**Plugging and Abandonment Procedure
Horseshoe Gallup Unit No. 13
Attachment "A"**

**UNITED STATES DEPARTMENT OF THE INTERIOR
BUREAU OF LAND MANAGEMENT
FARMINGTON FIELD OFFICE
1235 LA PLATA HIGHWAY
FARMINGTON, NEW MEXICO 87401**

Re: Permanent Abandonment

Well: 13 Horseshoe Gallup Unit

WELL NAME 13 Horseshoe Gallup Unit
 SEC, TWN, RNG. 32-31N-16W

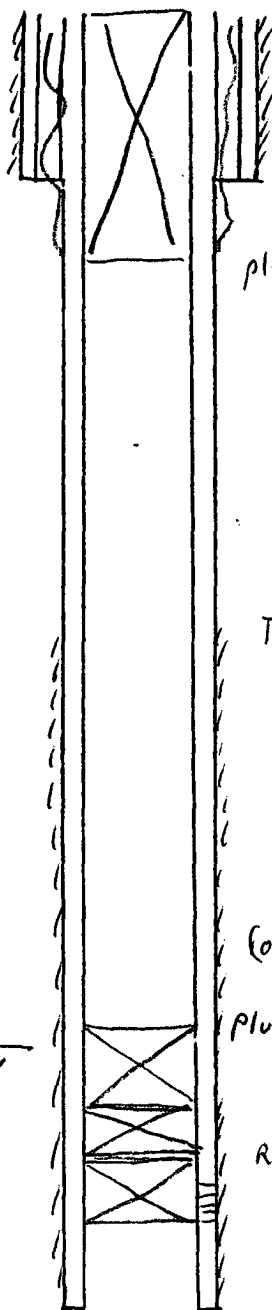
a) Bring the top of the Gallup plug to 823'.

b) Place the Surface plug from 150' to surface inside and outside the 5 1/2" casing.

- BLM geologist's pick for the top of the Gallup fm. reflects the top of the transitional Tocito interval in this well. This top varies from operator's pick in this well.
- It is recommended that the Gallup plug be extended upward to adequately isolate the Gallup top identified in this report.

plug 150 - surface w/ 50 sks

$$(1085 - 832) + 150 / 7.299(1.18) = 35 \text{ sks or grease}$$

Plug 1085' - 832'
